*City of Rancho Palos Verdes*  
**Rancho Palos Verdes ADA Assessment**  
**Facility Report with Photos**

**Facility ID: # 08 - Ladera Linda Park & Community Center**

Location: Top Stairs Photo # 62

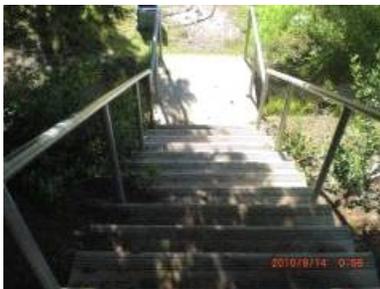
<b>Field Condition</b>	
08.05A - Exterior Stairs - Color Strip - Contrasting color strips have not been provided.	1991 ADAAG -
Existing Condition: No stripes.	2004 ADAAG -
	2007 CBC 1133B.4.4
	Other -

Location: Top Stairs      Photo # 69

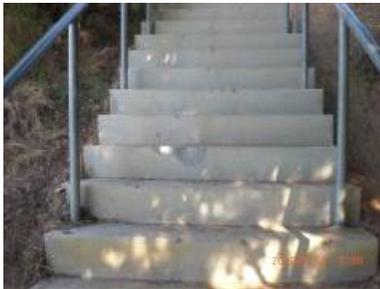
<b>Field Condition</b>	
08.18 - Other - Stairs - See Additional Comments	1991 ADAAG -
Existing Condition: Damaged stair surface.	2004 ADAAG -
	2007 CBC -
	Other -
